Monticello Nuclear Generating Plant  
Docket No. 50-263  
Renewed Facility Operating License No. DPR-22

Monticello Nuclear Generating Plant's Eighth Six-Month Status Report in Response to March 12, 2012 Commission Order Modifying Licenses with Regard to Requirements for Mitigation Strategies for Beyond-Design-Basis External Events (Order Number EA-12-049) (TAC No. MF0923)

**Spent Fuel Pool Instrumentation Clarification Introduction:**

Figure 1-1 – Spent Fuel Pool Levels (Revised)

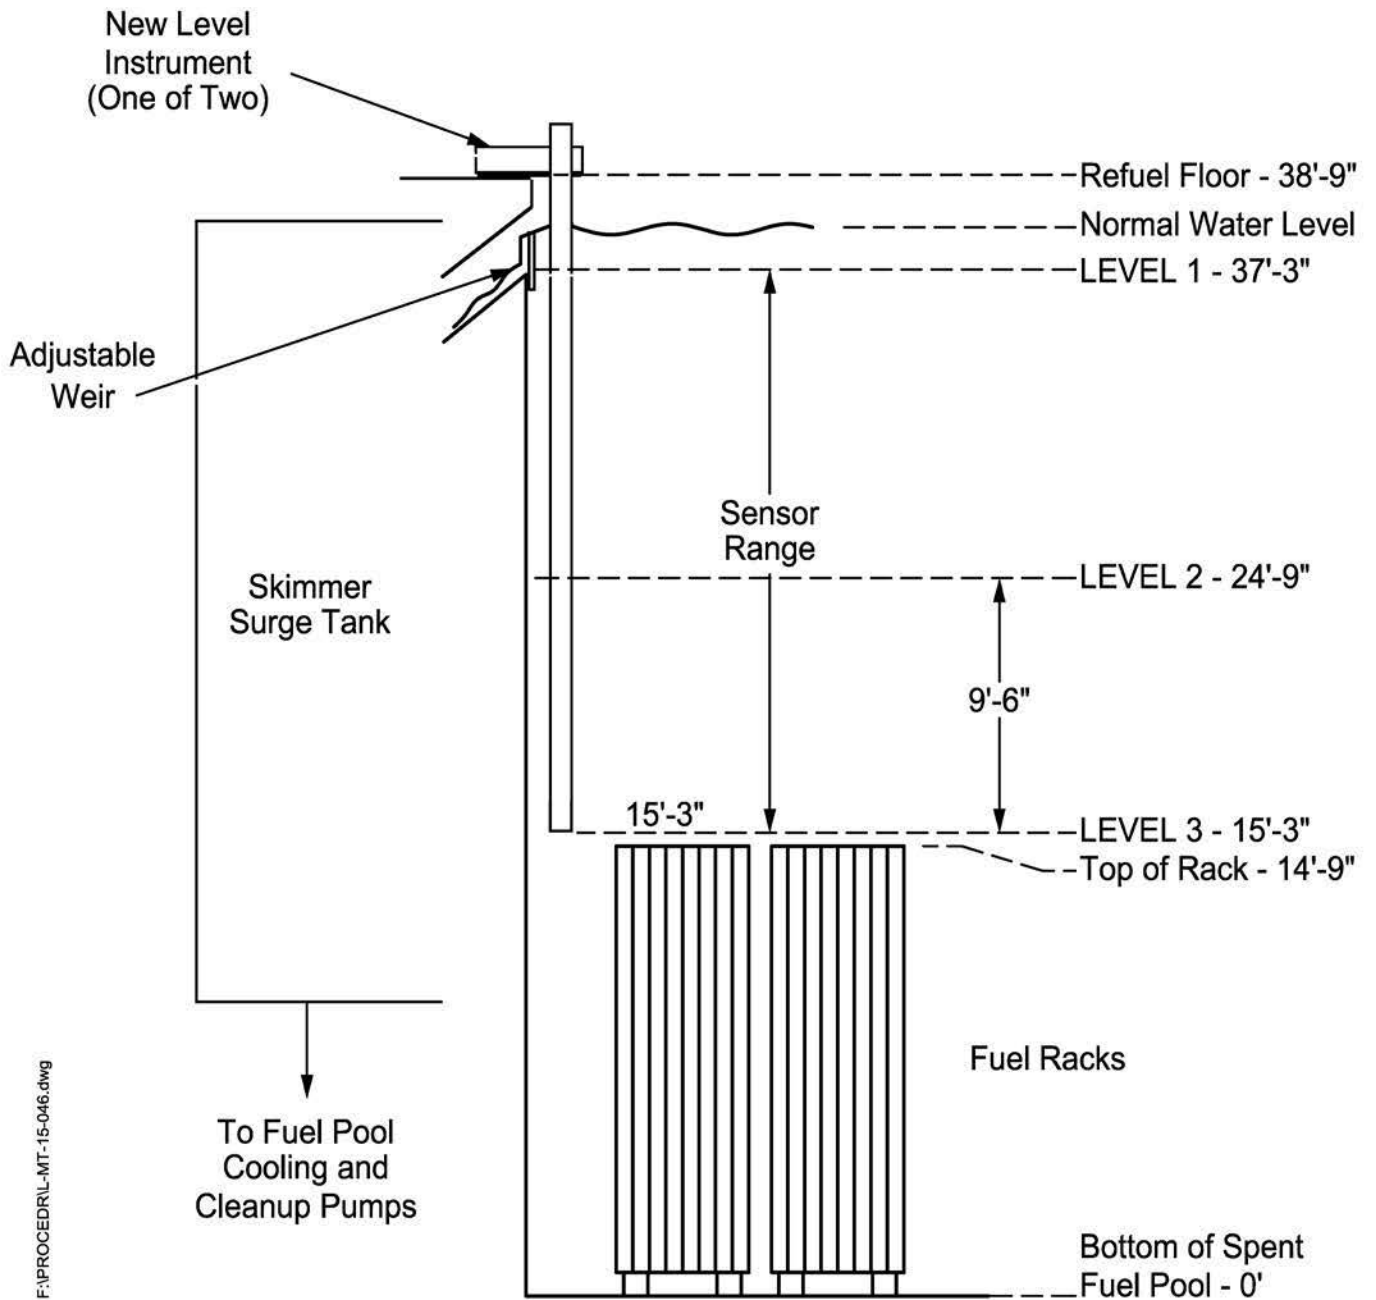
Subsequently, NSPM determined that certain information concerning SFPI levels and the instrument probe range required clarification. Specifically, the SFPI level probe does not extend the full range from Level 1 to Level 3 as stated in previous NRC correspondence. Below is the clarified information.

The SFPI probes installed in the MNGP SFP extend from the top of the SFP (mounted on the Refuel Floor) to a level 15' – 3" above the bottom of the SFP. In previous correspondence with the NRC (References 2 and 3) it was indicated that the sensor range of the probe extended from Level 1 to Level 3 with Level 3 defined as 14' – 9". To meet EA-12-051 requirements and in accordance with NEI 12-02, NSPM is redesignating the levels in the following manner based on the actual installed sensor range.

Figure 1-1 is revised and provided below. The revised figure shows the overall view of the levels and sensor range.

Level 1 remains unchanged at 37' – 3" above the bottom of the MNGP SFP.  
Level 2 remains unchanged at 24' – 9" above the bottom of the MNGP SFP.  
Level 3 is changed to 15' – 3" above the bottom of the MNGP SFP.

Level 2 is not changed, but is now less than 10' from Level 3. This continues to be acceptable as NEI 12-02 requires that Level 2 be 10' +/- 1' above the highest point of any fuel rack seated in the spent fuel pool. The highest point of any fuel rack in the MNGP SFP is 14' – 9". Therefore, 24' – 9" remains within NEI 12-02 requirements.

Level 3 is changed from 14' – 9" to 15' – 3" above the bottom of the SFP. Previously, Level 3 coincided with the highest point of any fuel rack in the MNGP SFP. However, since the probe for SFPI level does not extend from the top of the SFP down to 14' – 9", above the bottom of the SFP, it is not appropriate to consider this level as Level 3. NEI 12-02 states that Level 3 must be nominally (i.e., +/- 1 foot) positioned to the highest point of any fuel rack seated in the spent fuel pool. The revised Level 3 is approximately 6" from the highest point of any fuel rack seated in the MNGP SFP, thus meeting NEI 12-02 requirements. NEI 12-02 also requires that Level 3 should provide the maximum range of information to operators, decision makers and emergency response personnel. By using the full length of the probe, the MNGP installation meets this NEI 12-02 requirement. Finally, NEI 12-02 requires that designation of this level [Level 3] should not be interpreted to imply that actions to initiate water make-up must or should be delayed until this level is reached. The MNGP procedures require operators to begin looking for methods to refill the MNGP SFP prior to reaching Level 3. Therefore, use of 15' – 3" as Level 3 is an acceptable designation and meets all NEI 12-02 requirements.
